TB 358 – Cable screens passing through current transformers in Distribution Ring Main Units

Date: 30/10/2024

Correctly installed CTs in an ABB Safelink

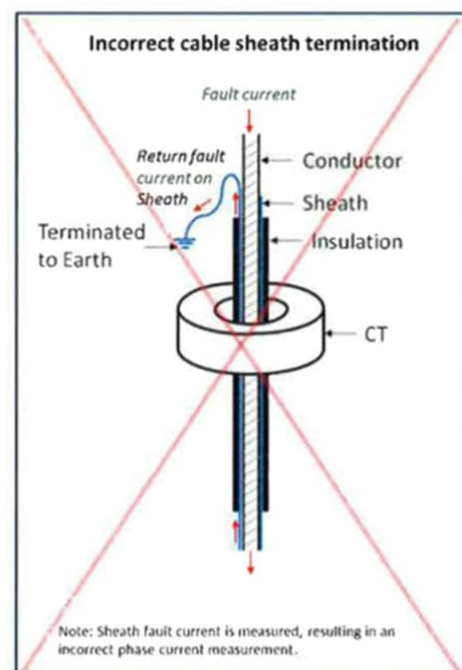
Through fault indication maloperations have occurred due to cable screens being incorrectly terminated after passing through a current transformer (CT) resulting in incorrect phase current measurement during fault conditions. Maloperations of this type occur when the cable screens are not taken back through the CT before being terminated to earth. Consequently, the detection:

- May not detect an earth fault on the circuit being measured. This occurs because the earth fault current through the cable may fully or partly return via the sheath, and these two currents (phase and sheath) will cancel each other out resulting in a reduction in the net current being measured.
- May operate unintentionally for faults on another item of plant or feeder. This occurs because some of the earth fault current from another fault can return via this cable screen and is incorrectly measured as fault current on the associated ring main unit (RMU) switch.

All jointers and installers of distribution RMUs must ensure the cable screens are properly terminated by passing through the CTs in switch units of automated RMUs and in circuit breaker RMUs. The CTs must be mounted concentric and perpendicular to the cables.

Incorrectly installed CTs in Siemens 8DJH

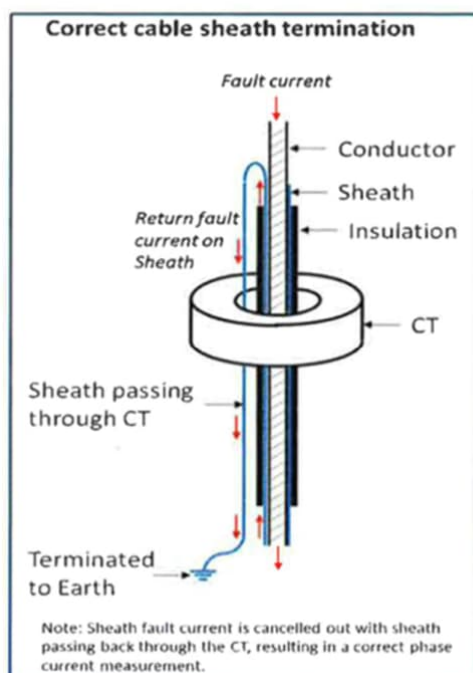
Since the introduction of automated RMUs in the distribution network, it has come to our attention that some jointers have not passed the cable screens through the CTs in automated RMUs.
